Access Compliance Report

Public Rights-of-Way

Intersection ID: 46809	Main Street: AZALEA_HILLS_DR	Cross Street: CLAUDE_FREEMAN_DR	Location: N
ADA ID: 325B266F6263	Ramp Type: PerpDiag	Initial Pass/Fail: Fail	Overall Compliance: No
Severity Score: 48.75			
Codes/Mitigation Info/Possible Solution		Field Measurements/Component Compliance

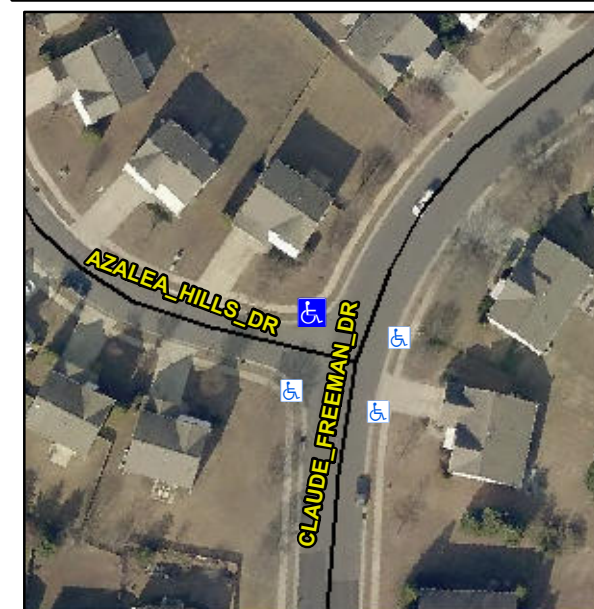
R304.5.1, R304.2.2, R304.5.3

Compliance	Description	Data	Compliance	Description	Data
N/A	Ramp Length (in)	48.0	No	Ramp Slope (%)	8.9
No	Ramp Width (in)	27.5	No	Ramp XSlope (%)	2.2
N/A	Flare Type LT	N/A	N/A	Flare Type RT	N/A
N/A	Flare Slope LT (%)	N/A	N/A	Flare Slope RT (%)	N/A
N/A	Flare Traversable LT?	N/A	N/A	Flare Traversable RT?	N/A
N/A	Landing Length (in)	N/A	N/A	DWS Provided?	N/A
N/A	Landing Width (in)	N/A	N/A	DWS Contrast?	N/A
N/A	Landing Slope (%)	N/A	N/A	DWS Length (in)	N/A
N/A	Landing X Slope (%)	N/A	N/A	DWS Full Width?	N/A
N/A	Landing Curb? (Y/N)	N/A	N/A	DWS Offset (in)	N/A
N/A	Shared Landing?	N/A			
N/A	Gutter Ponding?	N/A	N/A	Gutter Slope (%)	N/A
N/A	Gutter Lip Ht (in)	1.0	N/A	Gutter X Slope (%)	N/A
N/A	Painted X Walk1?	No	N/A	Painted X Walk2?	No
	X Walk 1 Direction	To SW		X Walk 2 Direction	To SE
N/A	X Walk 1 Width (in)	N/A	N/A	X Walk 2 Width (in)	N/A
	X Walk 1 Slope (%)	4.8		X Walk 2 Slope (%)	0.6
	X Walk 1 X Slope (%)	1.2		X Walk 2 X Slope (%)	3.9

Remove & Replace Curb Ramp With Two New Directional Ramps or Equivalent.
